From: Nick Chadwick
Sent: Monday, June 6, 2022 5:21 PM
To: Joann Meneaud
Subject: Hill Farm, Hempsted appeal consultation responses 20/00315/OUT

I have reviewed the applicant's response (their ref : Enzygo CRM.1132.021.HY.L.001.B) to earlier comments below.

From: Nick Chadwick
Sent: Thursday, July 2, 2020 3:31 PM
To: Joann Meneaud
Subject: Land at Hempsted Lane - Gladmans 20/00315/OUT

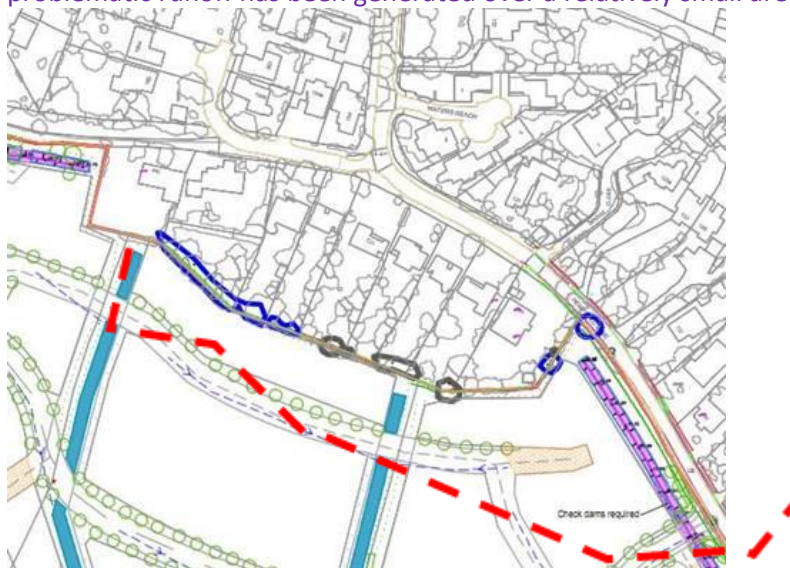
An intercept swale (with check dams) has been provided along part of the northern boundary – in purple below (where a gravity connection around the east / west of the site is possible). This leaves a section in the centre (shown below in red) which remains unprotected. Can an intercept swale / ditch please be added here. It could be connected into the proposed swales (blue lines), with an appropriate allowance for the attenuation provision. I appreciate that the highway will intercept overland flows from north of the highway, but we have had similar (sloping, clay) sites before where problematic runoff has been generated over a relatively small area.

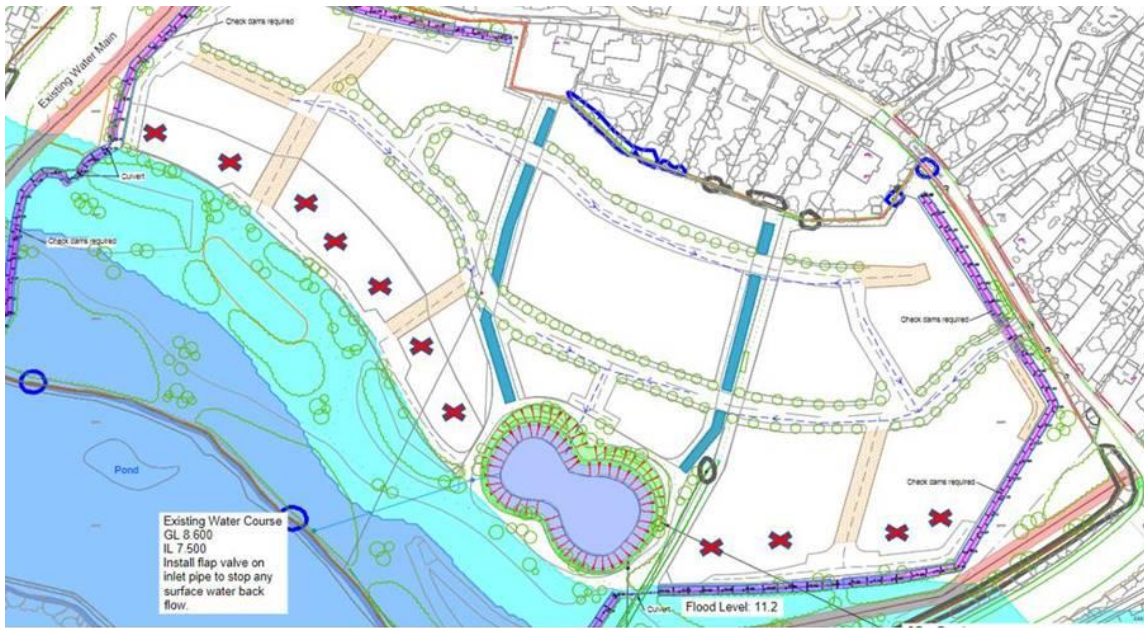
The drainage strategy presented is fairly basic. I am concerned that the new dwellings located closest to the bottom of the site ('X's below) will not be able to discharge by gravity to the surface water drainage pipework shown which in places is a long way up hill from new dwellings. Clarity is sought here.
